FLYING HORSE NORTH FILING NO. 8
PRI #2, LLC.
EL PASO COUNTY, CO

PCD FILE NO.: SF2531

CONSTRUCTION DRAWINGS
OVERALL SITE PLAN

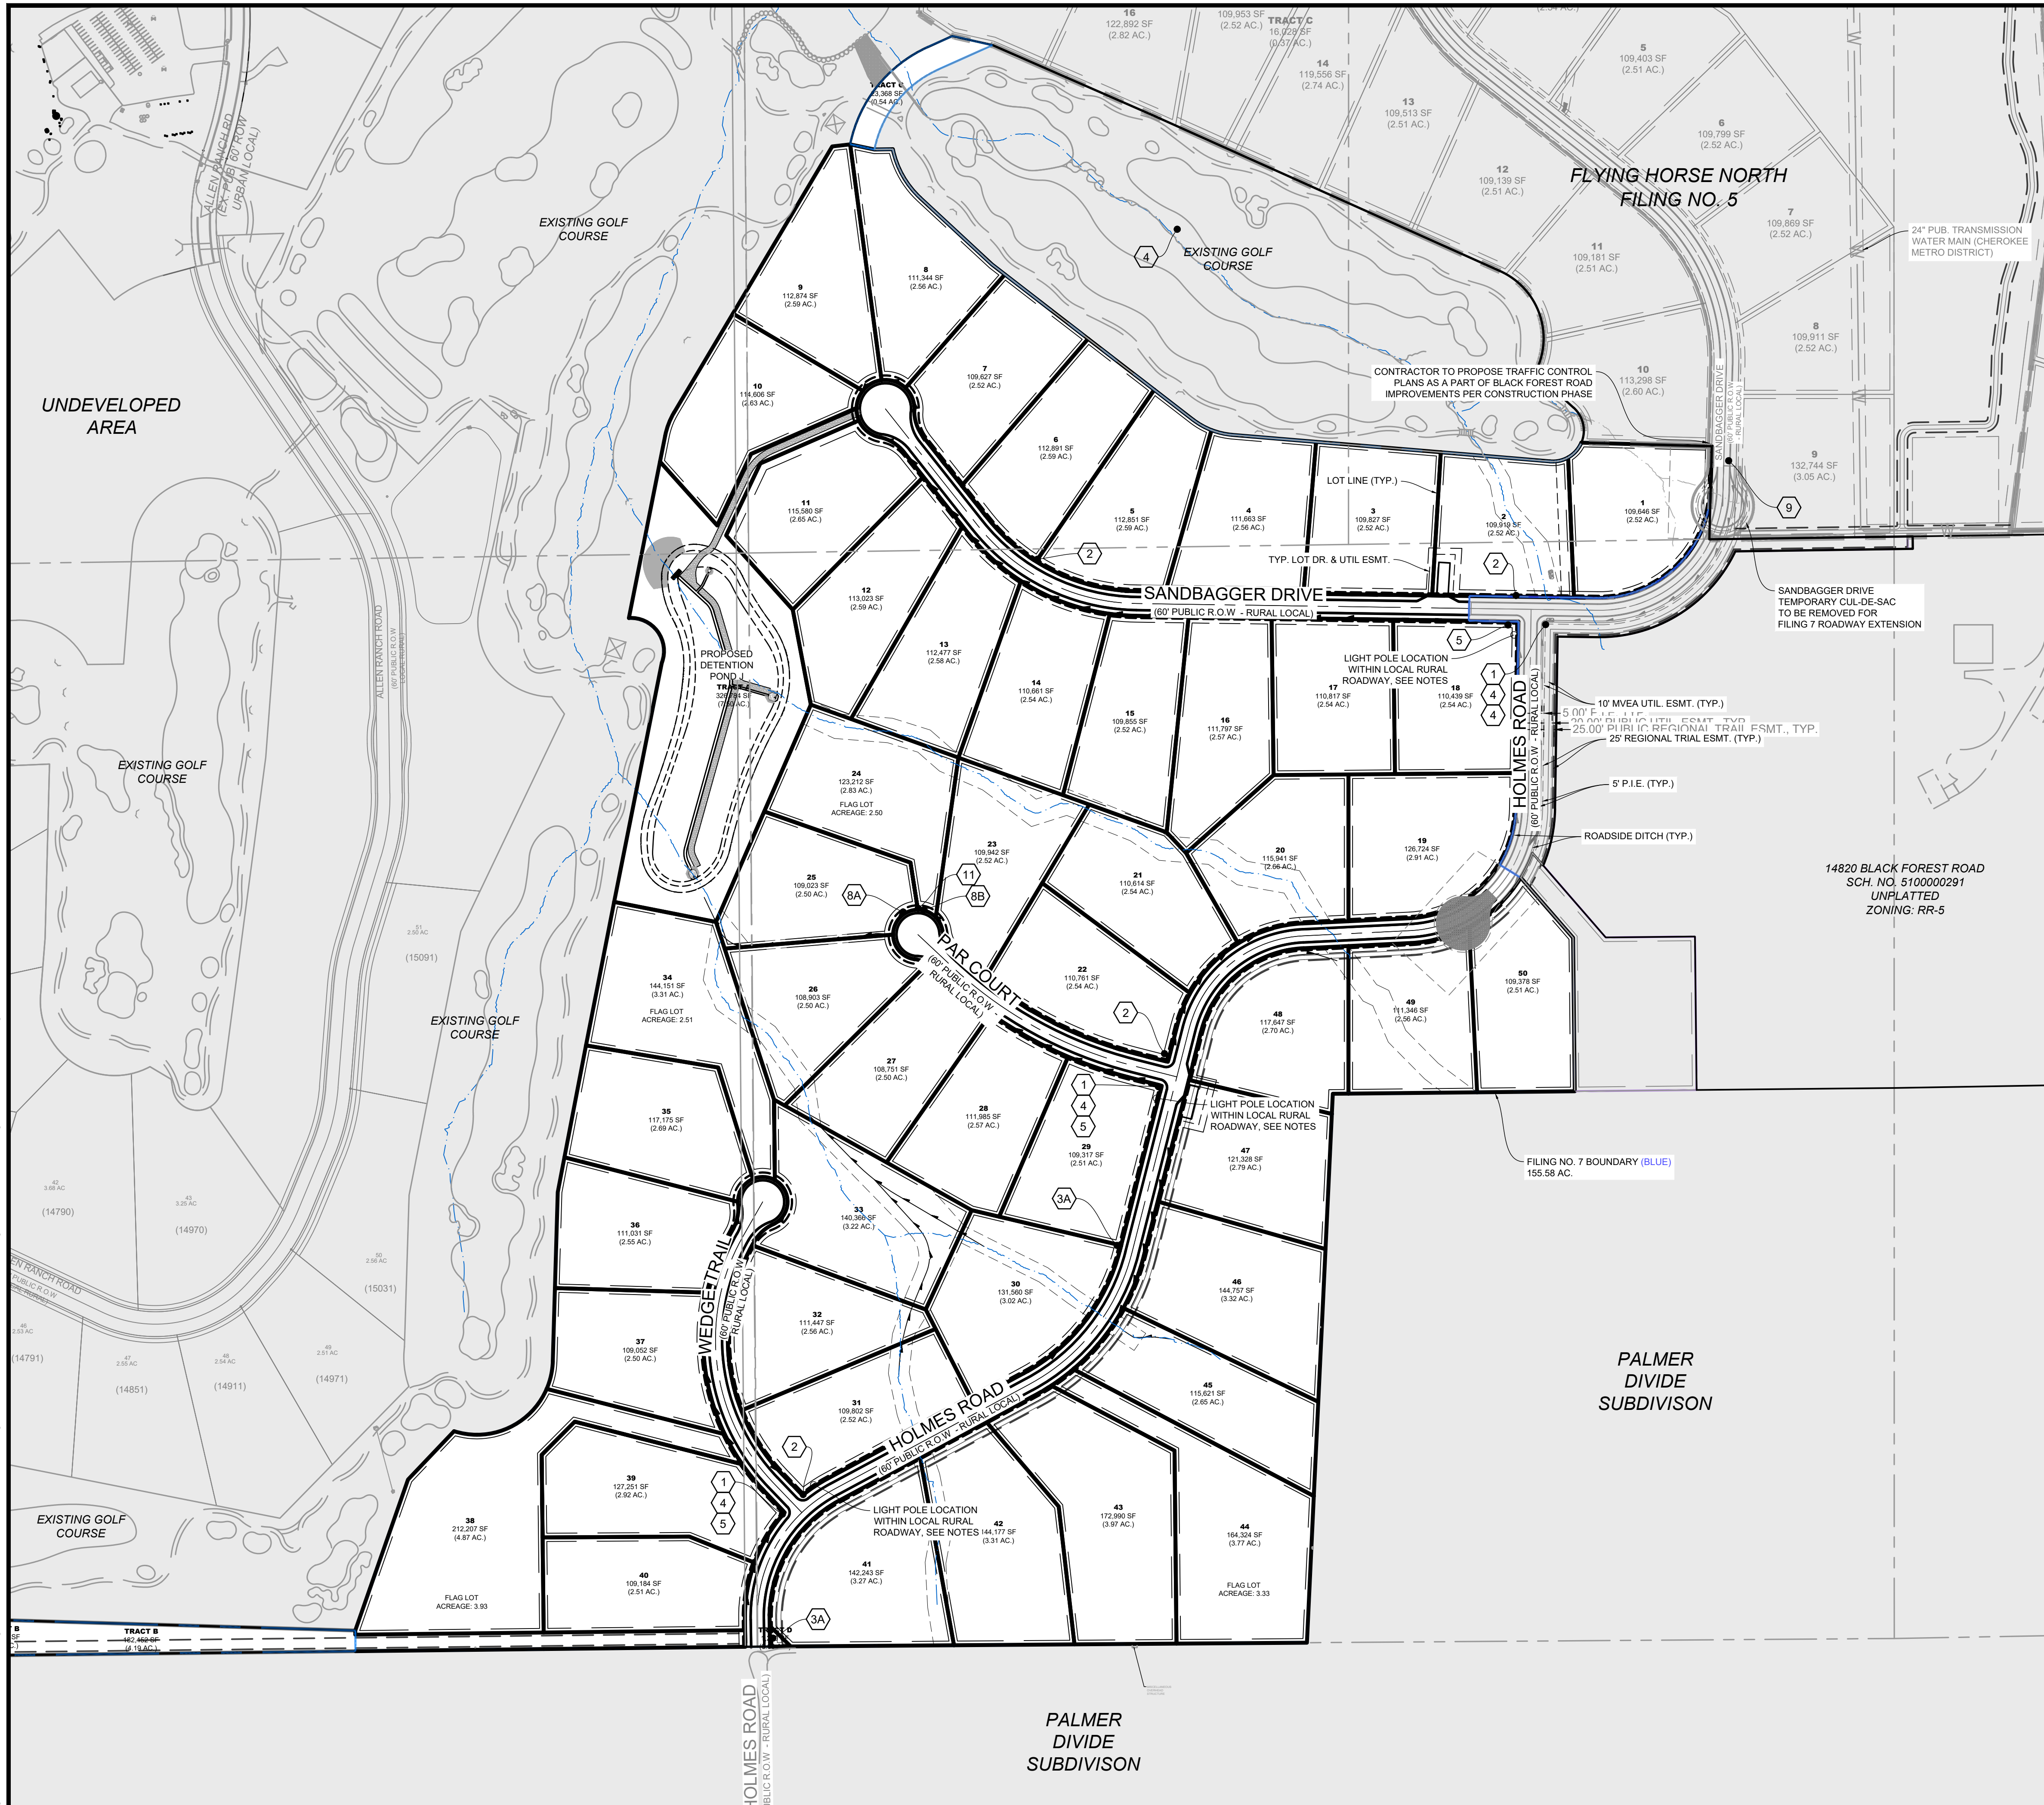
sight distance is 335 for 30mph design speed

HRG Response:
Sight distance line updated.

DETAIL
TRASH SCREEN & ORIFICE PLATE
SCALE: NTS

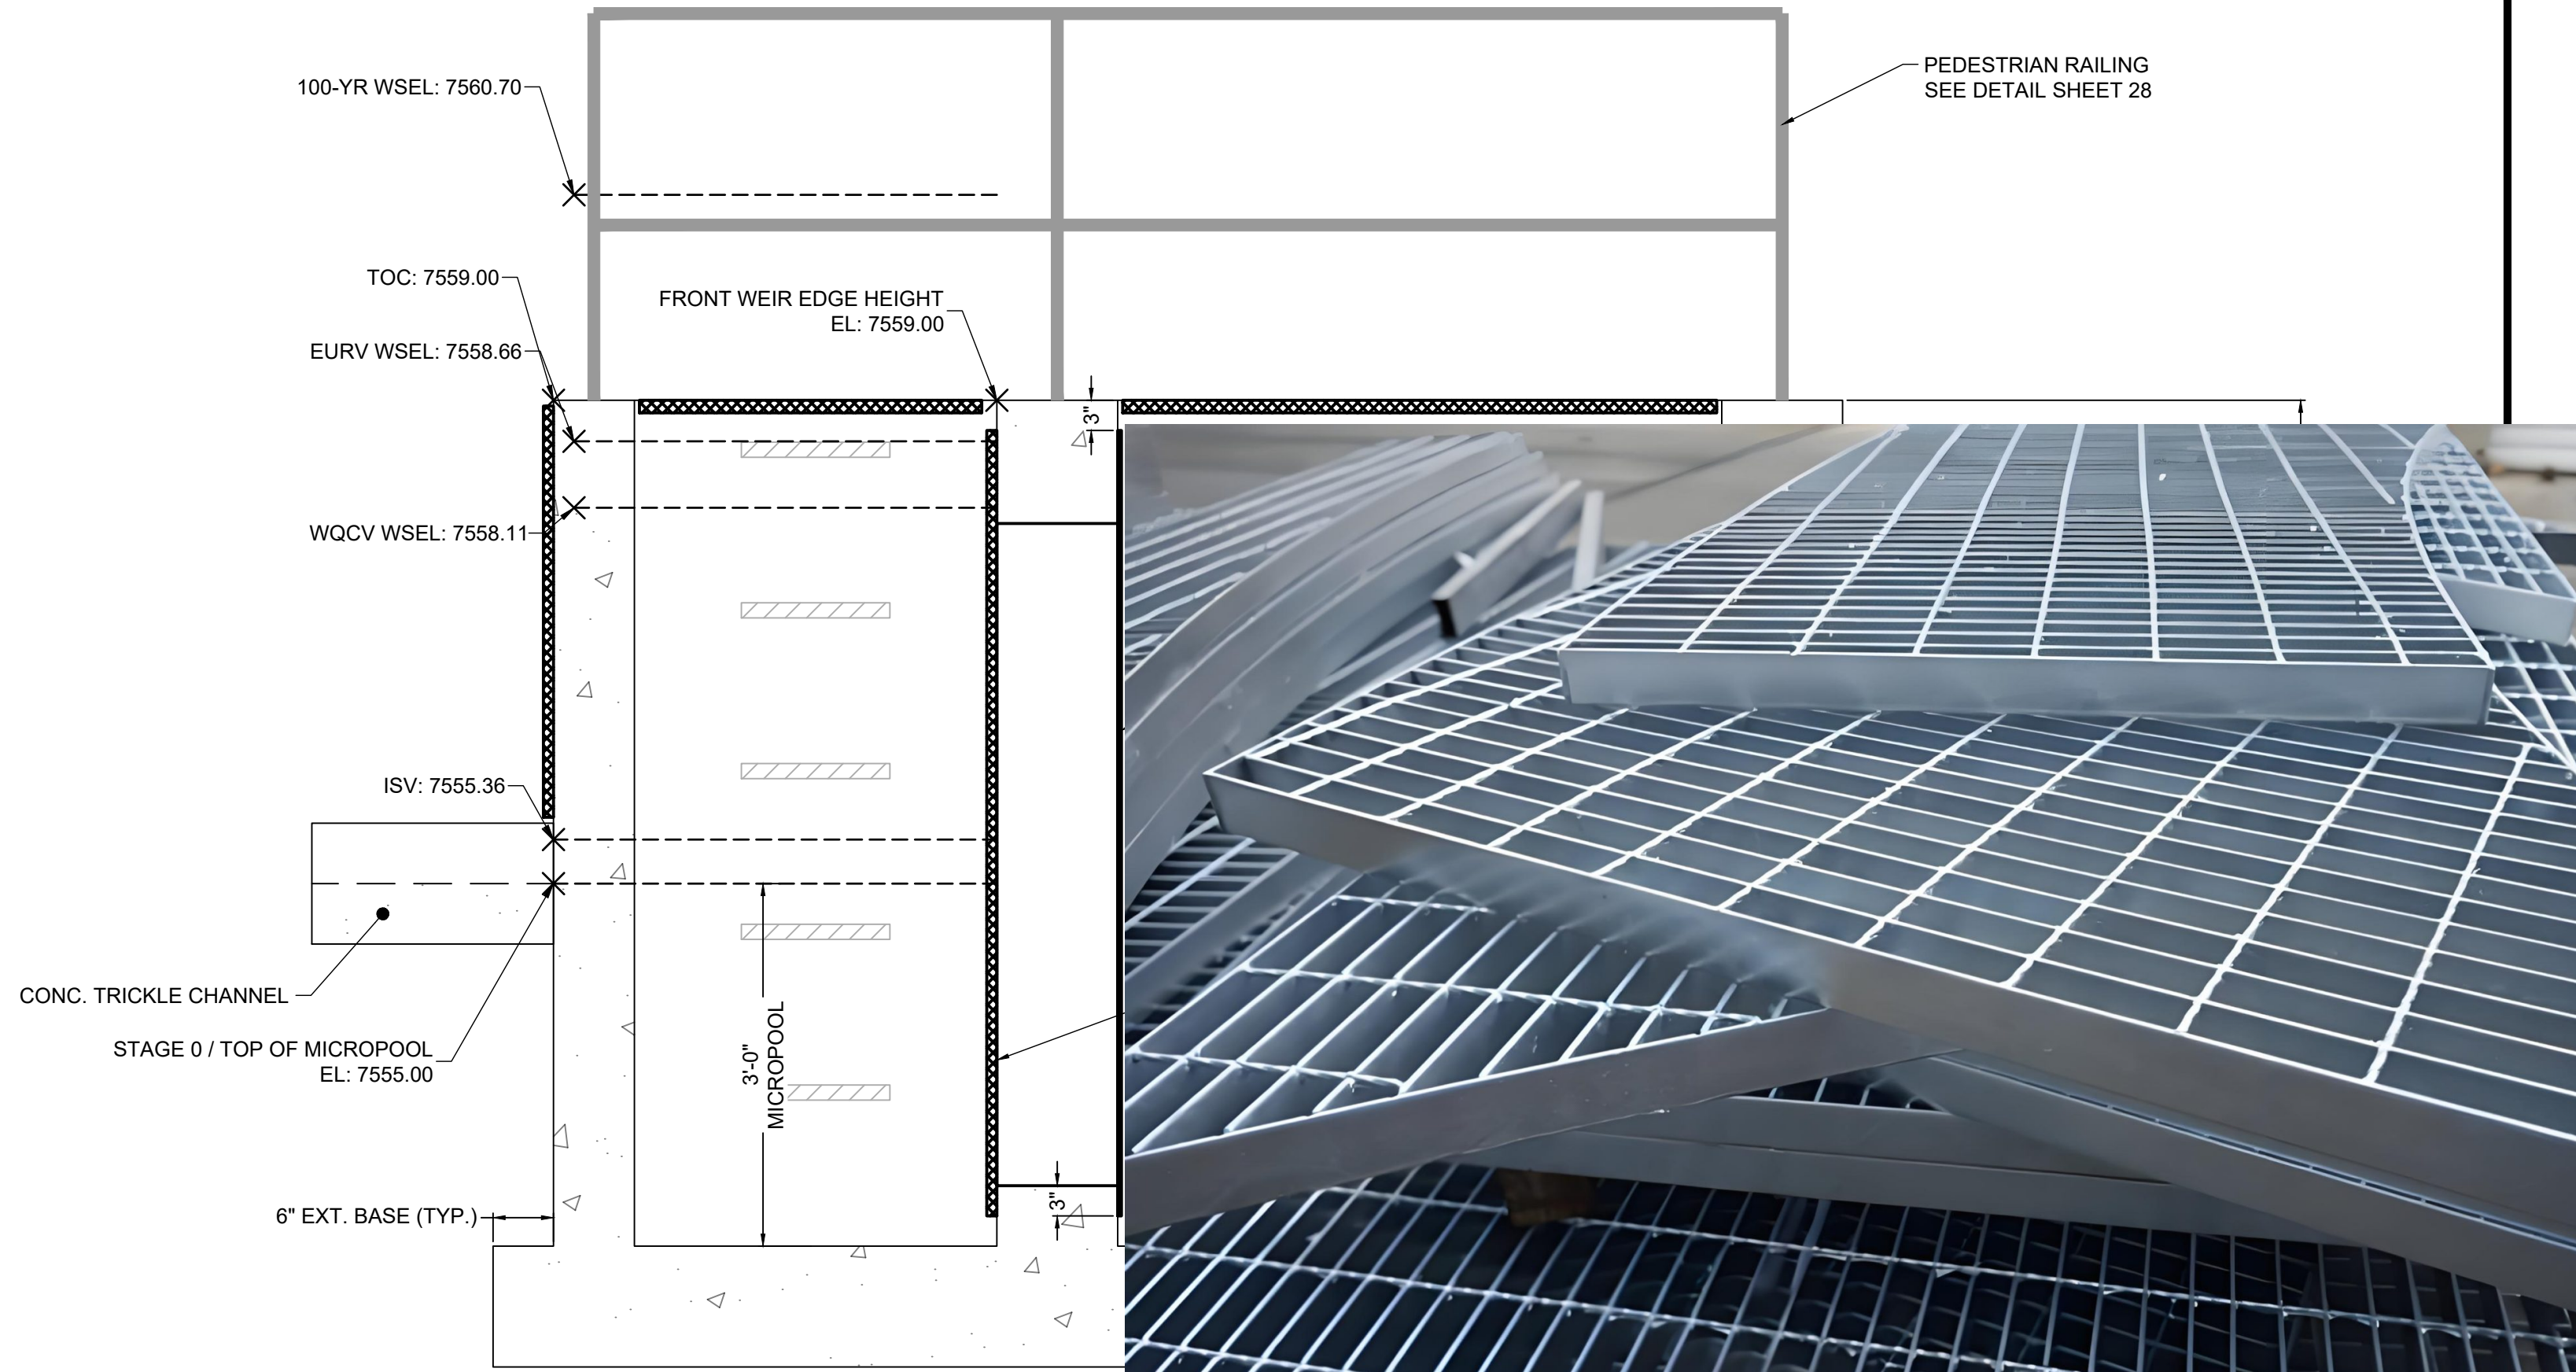
Unresolved previous comment
from Review 1 and 2:
Specify that bar grates should
be manufactured with exterior
bars in the vertical orientation.

HRG Response:
Banding bar on all sides
is intended to do this.
